## HISTORIC PRESERVATION REVIEW BOARD STAFF REPORT AND RECOMMENDATION

Landmark/District:	<b>Parkview School Modernization</b>	( <b>x</b> ) Agenda
Address:	<b>3570 Warder Street, NW</b>	( ) Consent Calendar
Meeting Date:	<b>June 28, 2012</b>	( <b>x</b> ) Alteration
Case Number:	<b>12-363</b>	( ) Addition
Staff Reviewer:	<b>Andrew Lewis</b>	( ) Demolition
		( <b>x</b> ) Conceptual Design

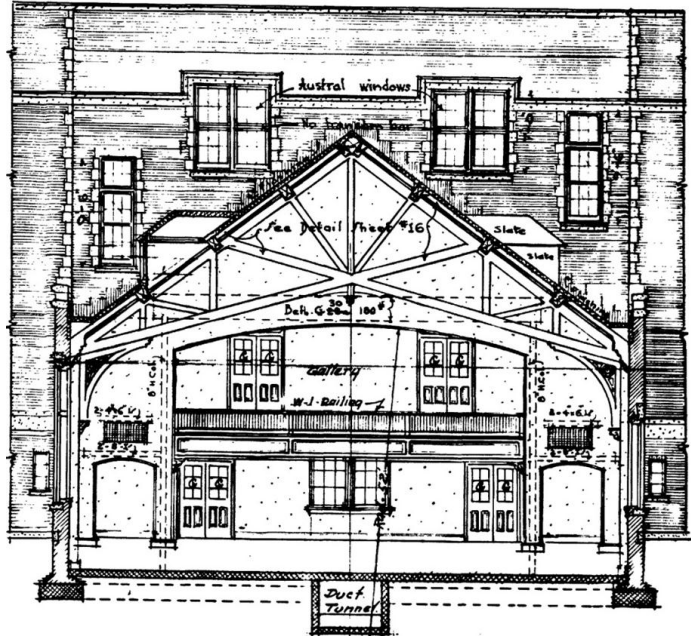
Originally, the auditorium's two sets of double doors (see image to the right) might have suggested a destination but the doors were removed at some point and the large openings were filled in and fitted with smaller, non-descript metal doors. The central window indicated on the lower level was also removed or never existed. The current proposal will restore the full sized openings and introduce new doors, sidelights and multi-light transoms that are based on the historical precedents. An additional window and transom will be inserted between the original openings to provide visitors with a view directly into the "Welcome Center" from the main entry level. A
